**PRELIMINARY/FINAL DRAINAGE REPORT  
FOR  
REDTAIL RANCH FILING 1**

JULY 2018

CCES FDR  
Responses

SP-18-004/SF-18-021

## DESIGN POINT D9

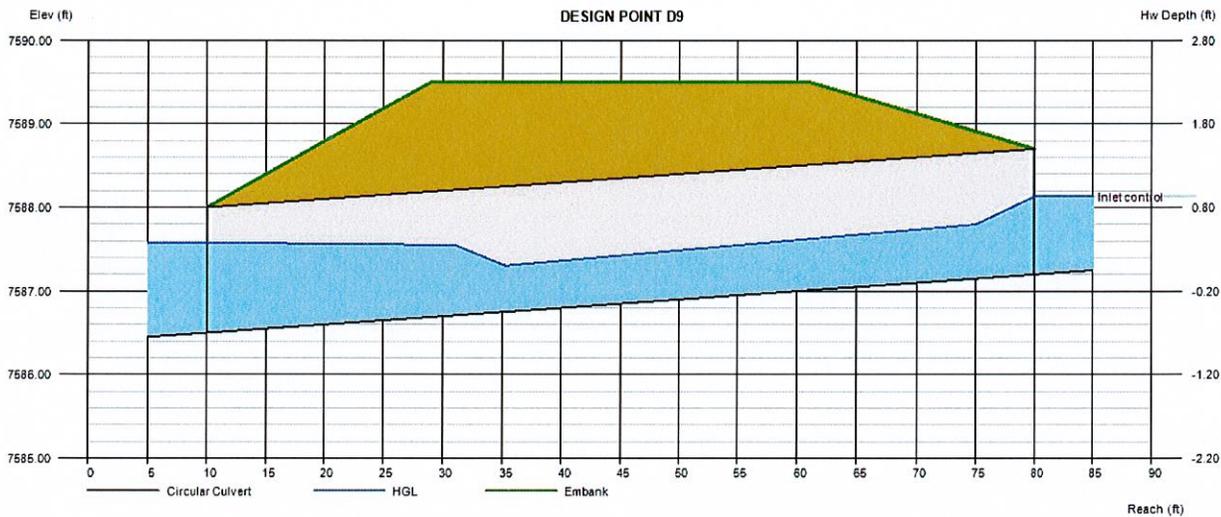
Provide for D8, D10
